Subject: Bug in 3K CRAM

The new batch of 3K CRAM boards have an error on them. There is a jumper wire from A61-5 to A60-8 (p. 3 of fabrication instructions) that should not be there. It causes flakey Ethernet behavior on some machines. I found this error during the last round of debugging, but SPG failed to delete this jumper from the fabrication instructions, so it is likely that any boards you have received to date contain this error.

REWORK INSTRUCTION FOR CONTROL MODULE WITH 3K CRAM.
(REFER TO FIGURE1)

Title
ASSEMBLY, P.W.
3K CRAM

FIGURE 1

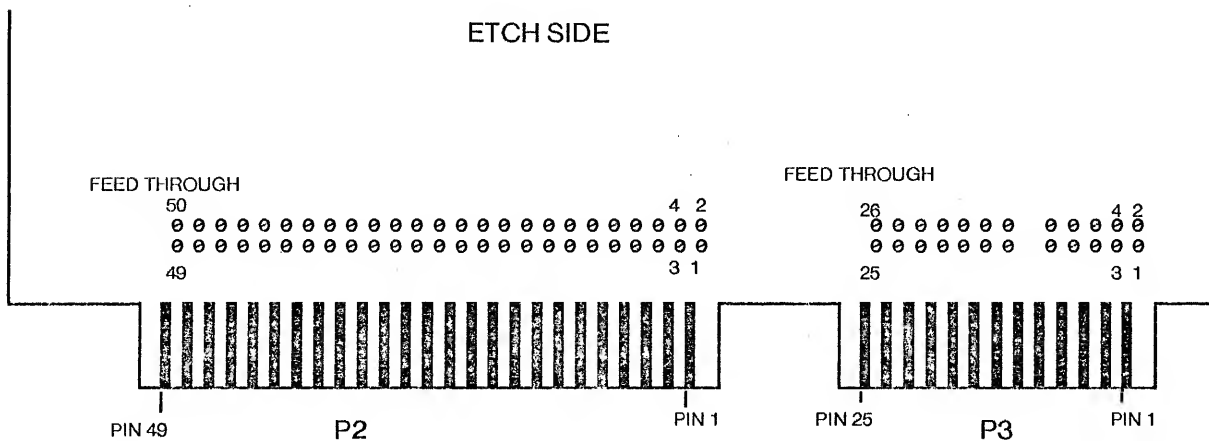
CUT ETCH TO FEED THROUGH P2-14 (ETCH SIDE)

CUT ETCH TO FEED THROUGH P2-12 (ETCH SIDE)

CUT ETCH BETWEEN U51-8 AND U51-7 (ETCH)

CUT ETCH TO U70-10 (ETCH SIDE)

ADD JUMPER FROM U37-12 TO U37-7 (ETCH)

ADD JUMPER FROM U51-7 TO U39-3 (ETCH)

ADD JUMPER FROM U68-9 TO FEED THROUGH P2-14 (ETCH SIDE)

ADD JUMPER FROM U68-12 TO FEED THROUGH P2-12 (ETCH SIDE)

ADD JUMPER FROM U25-11 TO FEED THROUGH P3-7 (ETCH SIDE)

ADD JUMPER FROM U25-3 TO FEED THROUGH P3-8 (ETCH SIDE)

ADD JUMPER FROM U25-4 TO FEED THROUGH P3-9 (ETCH SIDE)

ADD JUMPER FROM U25-6 TO FEED THROUGH P3-10 (ETCH SIDE)

REPLACE U51 WITH SW3K PROM (82S126)
